# Proposed Changes to ZOAC Recommendations

M. Novotny  
March 7, 2011

### R1-B Substandard Lot Example – 40' Wide

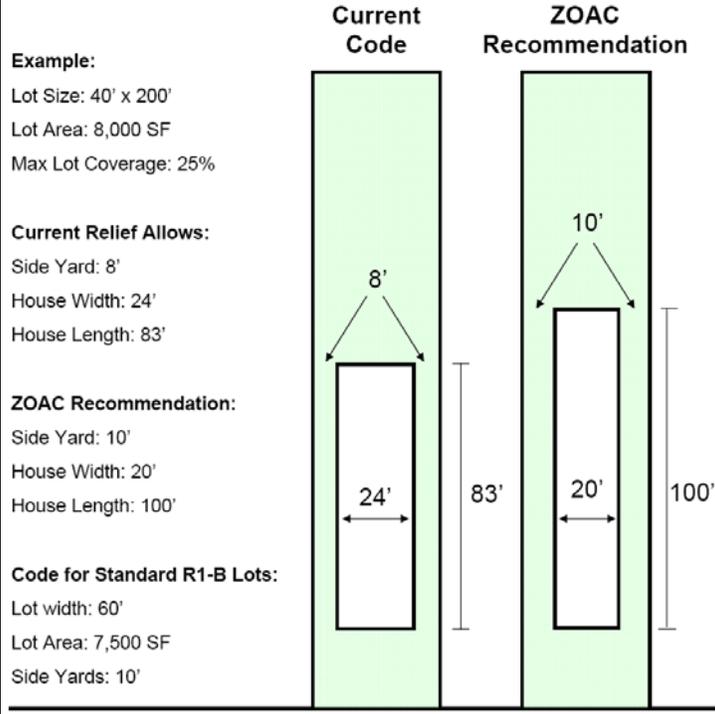
- Perhaps more importantly, this recommendation will make new homes even narrower than is currently permitted, which I don't believe was intended by the group. For example, a 40' wide R1-B substandard lot is currently permitted to have a 24' wide home. If the setback relief is eliminated, that same home would be reduced to **20' wide**. (See examples on pages 2).
- There remains an issue that under the current code a substandard lot "by area" can receive side yard setback reductions even if its "width" is conforming, and a substandard lot "by width" can receive rear yard setback reductions even if its "area" is conforming. The revision below addresses this.

Removing setback relief will create narrower homes on substandard lots. The proposed revision preserves needed side yard relief on a prorated basis.

**Prorate side yards based on actual lot width and prorate rear yards based on actual lot area (similar to how height is currently prorated). Setbacks would be reduced proportionately based on how close a lot is to being standard.**

- Sec. 48-1102 (b) (2) a. A substandard lot's minimum side yard ~~may be reduced to not less than 20 percent of the lot width, but not to less than 7½ feet in any case~~ shall be determined as a ratio of actual lot width to the required lot width multiplied by the maximum allowable side yard in the underlying zoning district. However, the substandard lot side yard shall not be less than 7 ½ feet in any case.

### R1-A Substandard Lot Example – 50' Wide

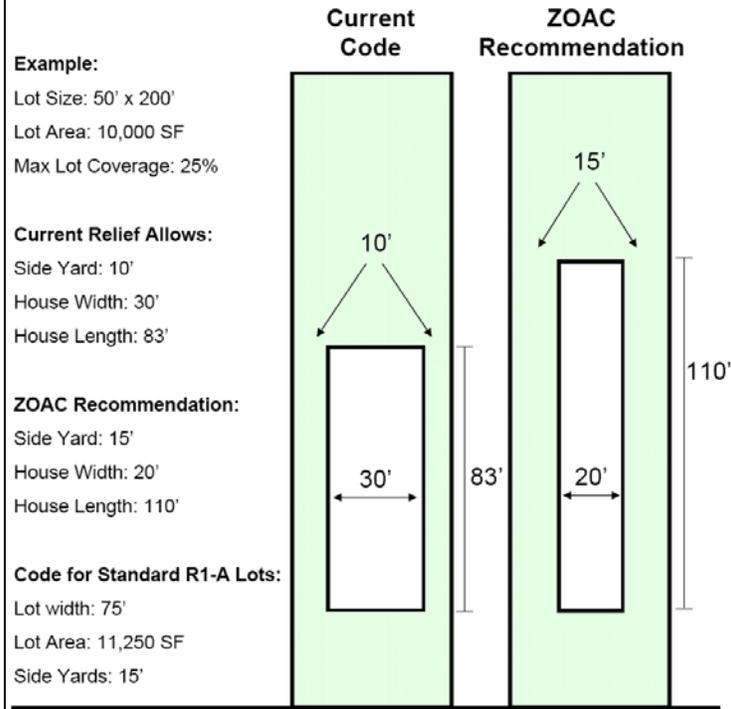
Removing setback relief will create narrower homes on substandard lots. The proposed revision preserves needed side yard relief on a prorated basis.

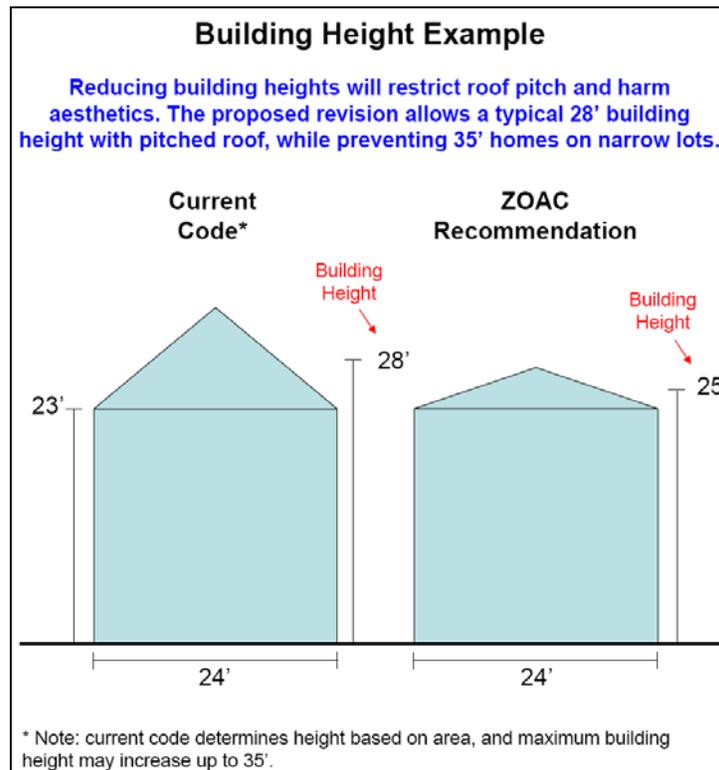
- This is a positive recommendation, however it requires one important adjustment regarding minimum building height.
- Most new two-story homes need a building height of at least 28' (\*may need up to 30' – 31' if lot is sloped) which allows for sufficient floor-to-floor height and an adequately pitched roof. Going below 28' in height will lower the roof pitch and make the home less aesthetically pleasing. (See example below)

- The ZOAC recommendation will push more lot owners below 28' in height. Specifically, any substandard lot owner with a 60' wide lot or less in R1-A and 48' wide lot or less in R1-B would be required to build below 28'. In each of these cases, homeowners will likely avoid gable roofs and instead opt for lower pitched or flat roofs.

- The minimum height should be adjusted from 25' to at least 28' to meet current construction standards and avoid the introduction of low or flat roofs.

**In addition to the ZOAC recommendation, change the minimum building height for substandard lots from 25' to 28' to meet current construction standards and avoid negatively impacting the exterior design of a new home.**

- Sec. 48-1102 (b) (2) c. The substandard lot building height shall be determined as a ratio of actual lot area to the required lot area or actual lot width to the required lot width, whichever is the lesser percentage, multiplied by the maximum allowable height in the underlying zoning district. However, the substandard lot building height shall not be required to be less than ~~25~~ 28 feet.
